Gillig Bus Blueprint

New Design Seat Layout

KIT & DIAGRAM, SEAT LF2010 40" X 102"
DENVER, CO
SL-76752-188593

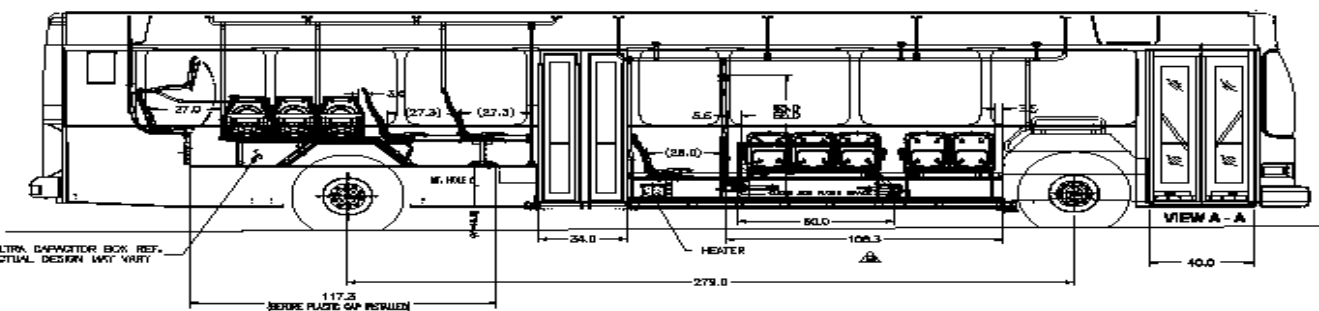
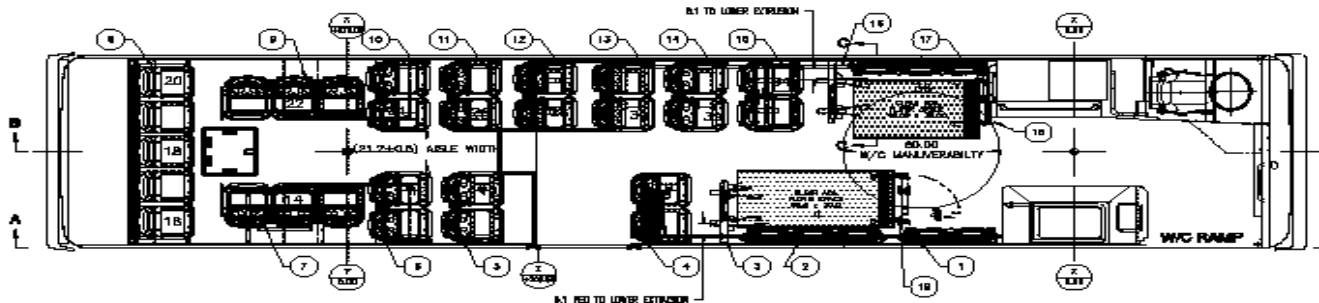
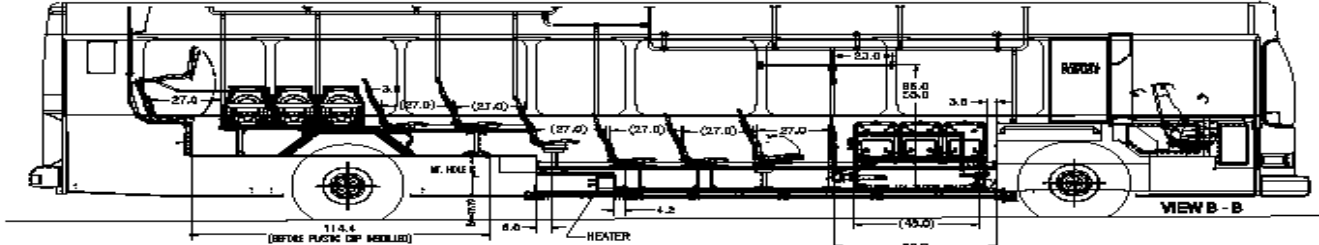
This blueprint is similar to the buses purchased in 2017 and 2019. The securement areas on both sides of the current buses are 30" x 48", securements use 4" of that space
Some powerchairs can be 27' x 44", making it difficult to parallel park their chair.

In 2016 RTD gave this drawing was given to a group of people from CCDC and APAC (ADA Paratransit Advisory Committee), however buses with the layout weren't purchased until 2019.

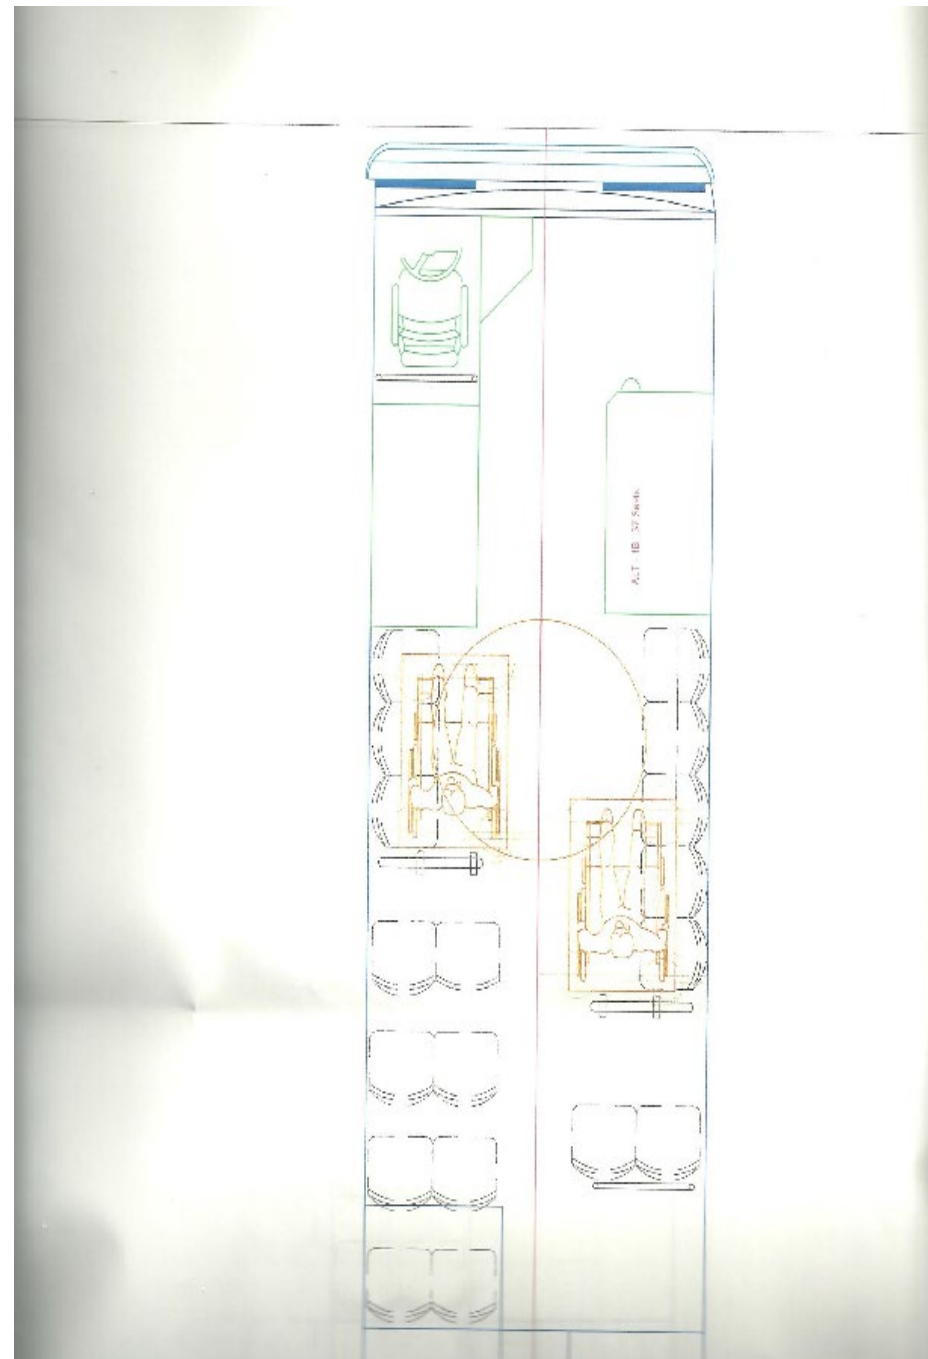
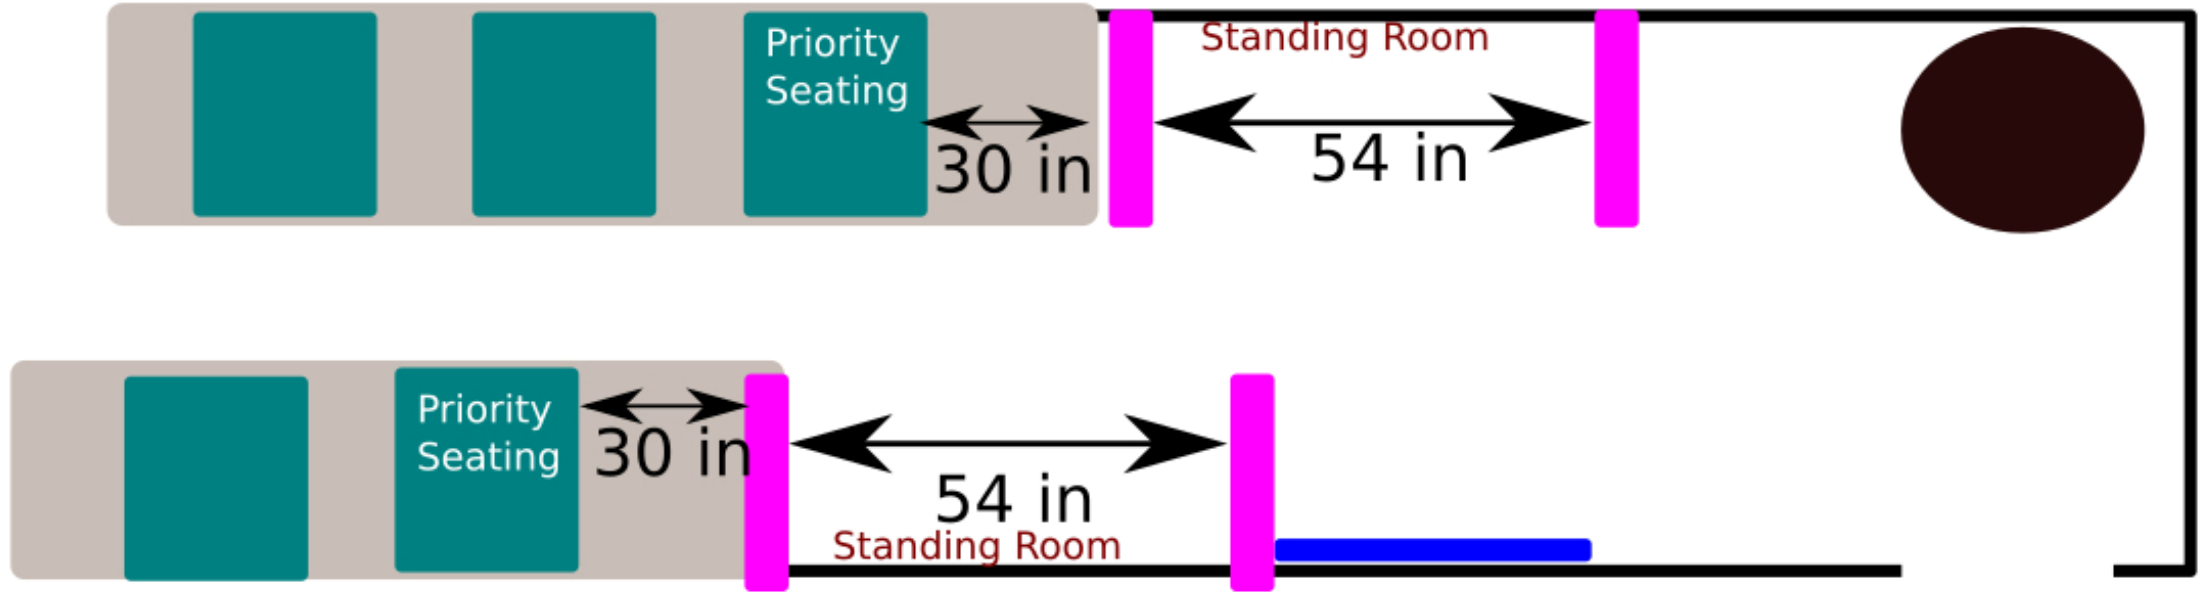
Now, most of the buses in the RTD Fleet have a floor plan like this.

A 2021 suggested bus design with a 30" x 54" sized securement area, more user-friendly than an ADA minimum 30" x 48" one.

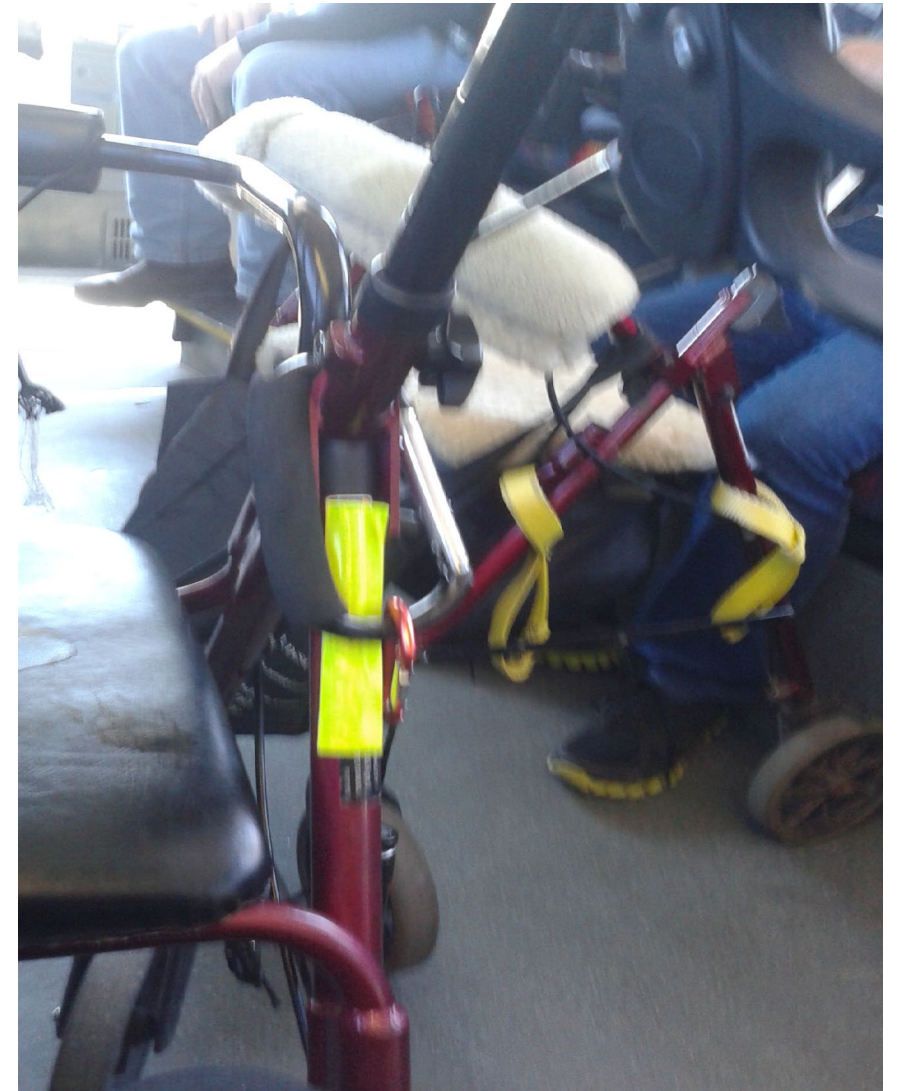
The forward-facing seats in the new Gillig buses have very little leg room so people have to put their walker in the aisle.

These pictures demonstrate how little legroom there is in a forward-facing seat and a main aisle crowded with walkers. By removing one seat to make the area between seats larger would make the bus safer and getting up from a seat easier.
